AGENDA

City of Salmon Arm Development and Planning Services Committee

Official Community Plan Amendment Application No. OCP4000-53

Zoning Bylaw Amendment Application No. 1255

Application No. DP- 447 1481 10 Street SW – IBA Architecture Inc. (Raman Beeston)

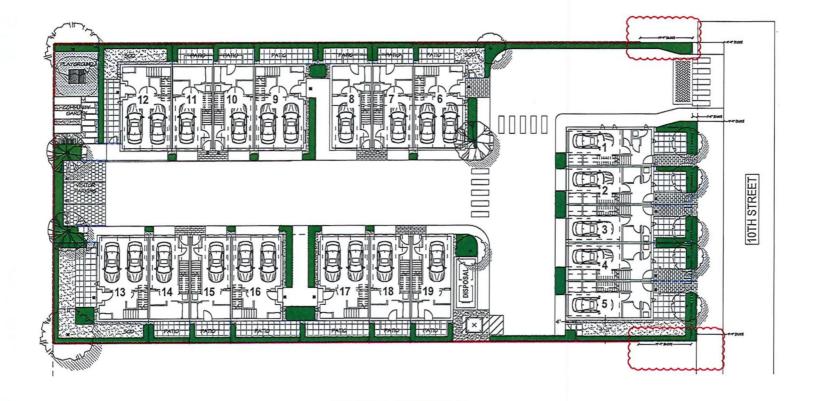
As noted on the site plan units 1 to 5 are oriented toward 10 Street SW. Street oriented buildings are encouraged in the OCP guidelines. The garages for each unit are accessed from an internal roadway. The building faces include multiple points of variation and relief and has been designed in consultation with the OCP. The landscaping shown on the plan includes fencing and areas consistent with the guidelines of the OCP. It was noted that along the west property line there is a shared boundary with the ALR. The applicant is proposing a 2m solid wood fence and common amenities along the boundary (play park and visitor parking) and this is consistent with ALC guidelines for developing adjacent to the ALR. In addition to the common areas on the west side of the site, the plan also shows a common garbage and recycling enclosure adjacent to the proposed unit #19; although, with individual garages unit pick up is an option through the City program. This area could be used for snow storage if curbside collection were used by the owners.

The Panel members noted that the streetscape, design and frontage has an urban appearance with a simple building presentation. The Panel was complimentary of building materials and attention to site planning details such as the common areas and snow storage/visitor parking. The Panel is enthusiastic about the development proposal and noted several positive components of the design and development proposal. The only noted concerns relate to the roof pitch and the snow load with the potential for snow falling on adjacent lots, entrances or units creating a hazard. It was noted the BC Building Code includes provisions to mitigate potential hazards brought about by snow loads.
